APR 21 1981

MEMORANDUM FOR: File

FROM: M. Chiramal  
Office for Analysis and Evaluation  
of Operational Data

SUBJECT: HATCH UNITS 1 and 2 - ALTERNATE OFFSITE SOURCE INTERLOCK WITH EMERGENCY DIESEL GENERATORS

DIESEL GENERATOR 1A U.V. RELAY LOGIC (TYPICAL)

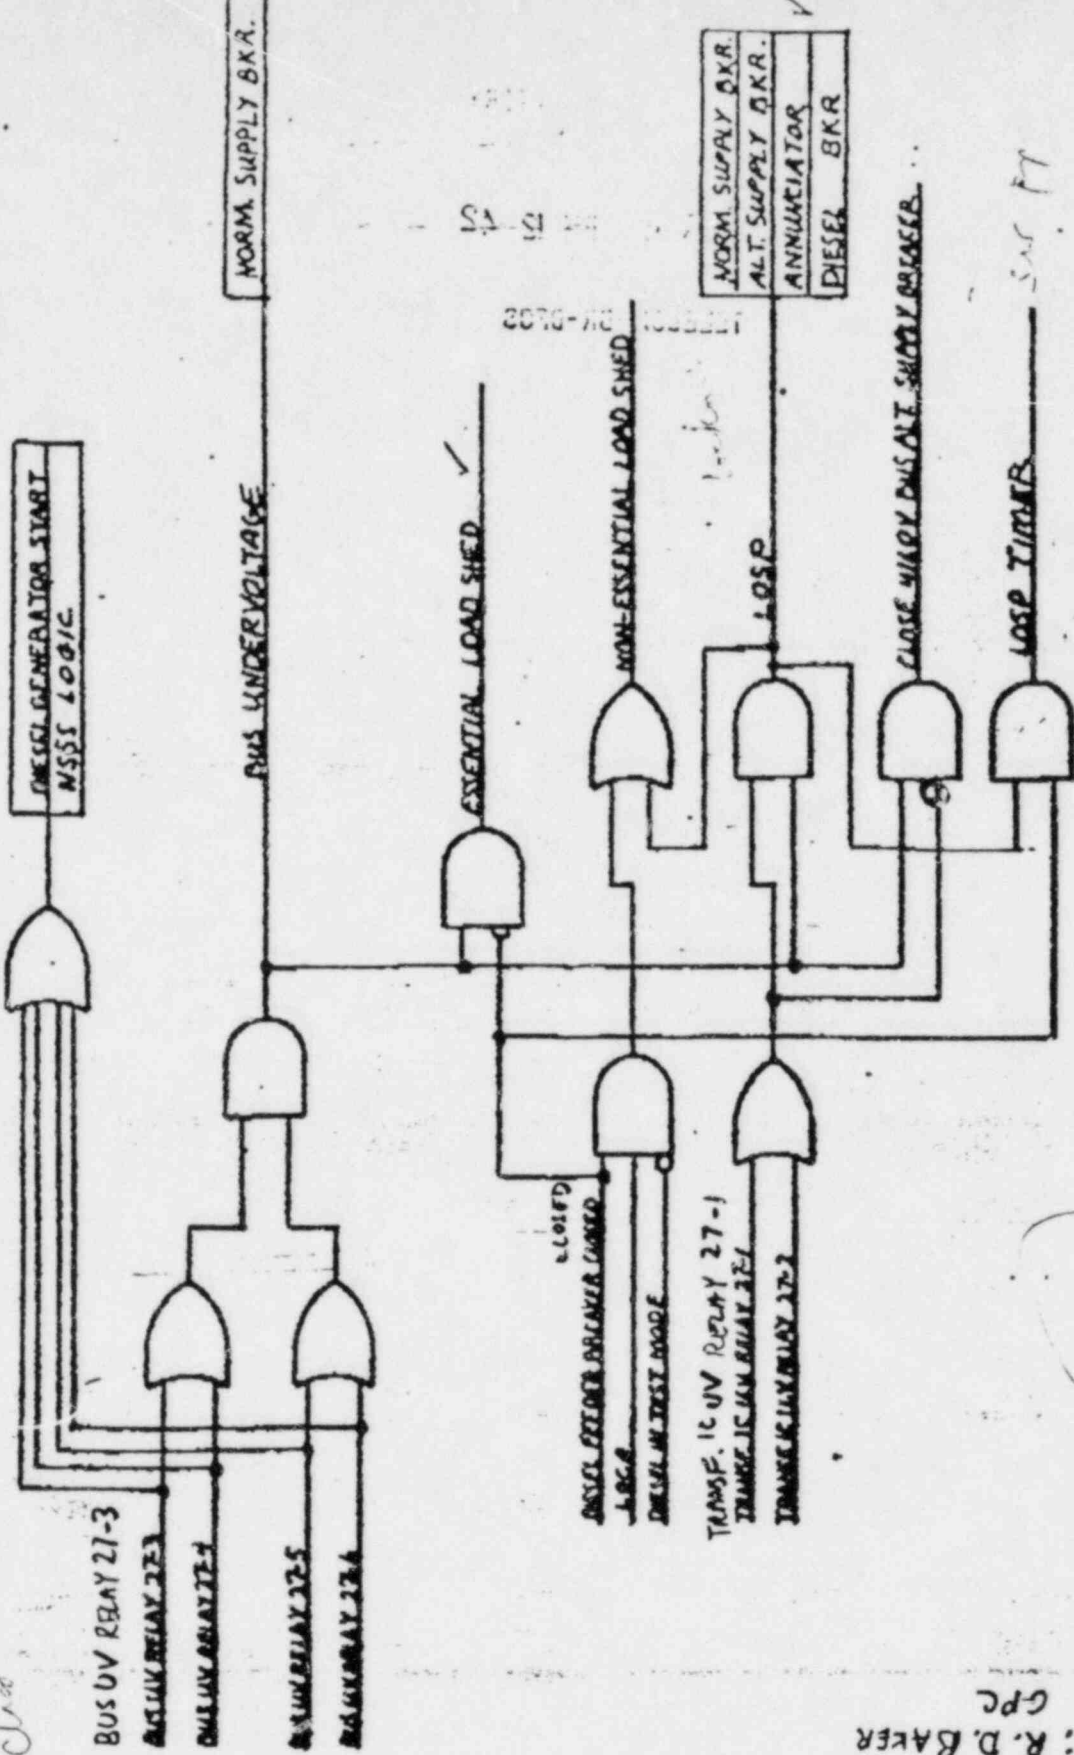
The licensee, while performing a relay trip procedure at Hatch 1, identified that the undervoltage relays of the second offsite source would not operate. The relays are designated "Transformer 1C UV relays 27-1 and 27-2." (see attached logic diagram). Transformer 1C is the alternate offsite source to the safety-related buses.

The UV relays 27-3 through 27-6 that monitor the voltage of each safety bus are designated as Class 1E equipment -- a set of four is provided for each bus. The UV relays 27-1 and 27-2, however, are not designated Class 1E and only one pair is provided for all the safety buses. On April 6, 1981 during the trip procedure, relays 27-1 and 27-2 did not operate, thus preventing the closure of all the DG breakers on Unit 1. The design is the same for Unit 2.

The licensee will be proposing a design modification to correct the problem of the non-Class 1E interlock that prevents the automatic operation of safety systems. ORAB/NRR is presently pursuing this matter. Other than keeping ourselves informed of the resolution of the design problem, we do not anticipate any further AEOD action.
